Errata Sheet

2008 Edition of SCDOT's *Access and Roadside Management Standards*

This errata sheet logs both content errors and minor implementation errors that have been identified since the release of the 2008 Edition of SCDOT's Access and Roadside Management Standards Manual. All page numbers refer to those indicated on the document pages and not the PDF formatted text. The corrected pages are included in this document.

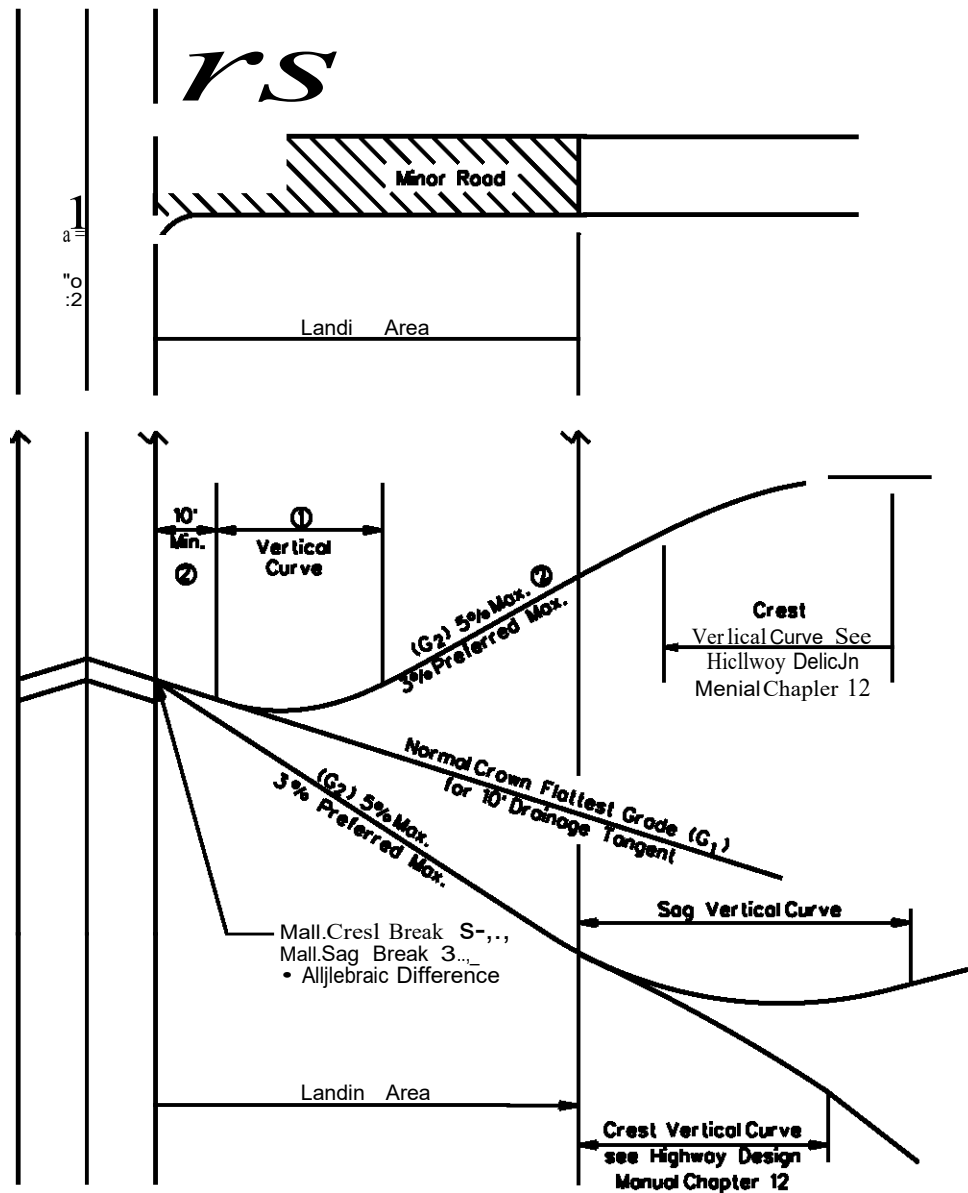
Subsection	Page	Description of Correction
Appendix A	A-6	Added *Algebraic Difference to the figure to define the maximum sag and crest break.
Appendix A	A-8	Corrected pavement markings for westbound approach.
Appendix B	B-1	The District 3 Office address should be 252 South Pleasantburg Drive, Greenville, SC 29607
Appendix F	F-1	The gross leasable area for the shopping center land use should be 3,000 sq. ft.
1A-3	6	Removed 57,500 Gallons fuel saved from Table 1-1
1B	7	Updated references to SC Code of Laws
3C-1	27	Figure 3-7 : Updated Middle Column title to read "Minimum Driveway Spacing (ft) on roadways with AADT \geq 2000 or Driveways Generating more than 50 Peak Hour Trips"
5D-4	49	Added "Storage" to the title captions of Tables 5-8 and 5-9 and removed "deceleration length" from the 2 nd sentence of the section
5D-5	51	First sentence – Changed "from 1 to 6 feet" to "to 1 to 6 feet" to match text found in the South Carolina Highway Design Manual

Figure 3-9: Corner Clearances

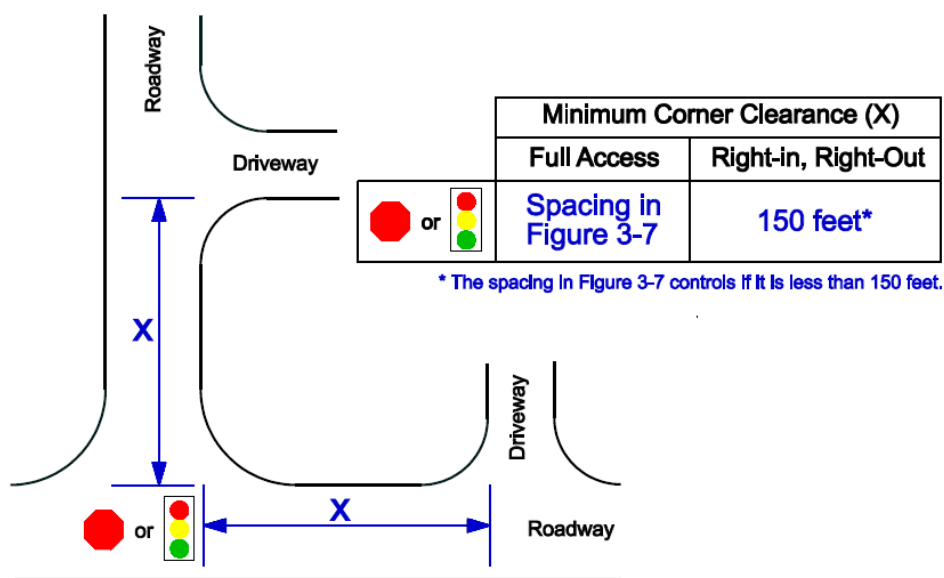
Subsection	Page	Description of Correction
3C-2	28-29	Modified text and Figure 3-9 to clarify the spacing requirements for right-in, right-out access.

FIGUREA-11

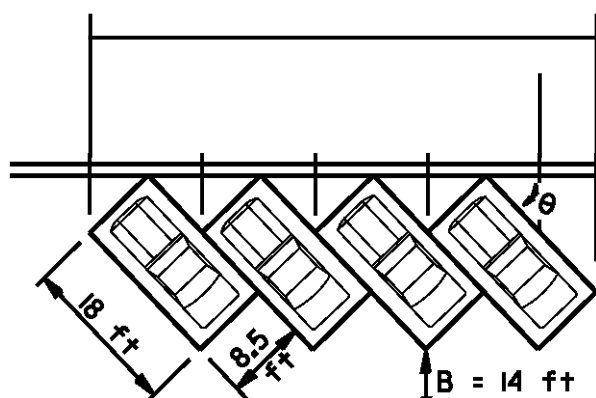
12A	90	Modified the last sentence of the last paragraph to read “One copy shall be kept in the district and one copy forwarded to the as-built plans office in Preconstruction Support to be scanned and placed in the SCDOT Plan Library.”
Page A-1		Added Figure A-11
Figure A-7.1		Added Right-In, Right-Out Figure
Figure A-11		Modified the distances for “B” in 30 and 45 degree parking to 11 feet and 14 feet, respectively. Added note to see SCHDM Figures 21.3A and 21.3C for parking lane widths.
Page B-4		Engineering District Map has changed.
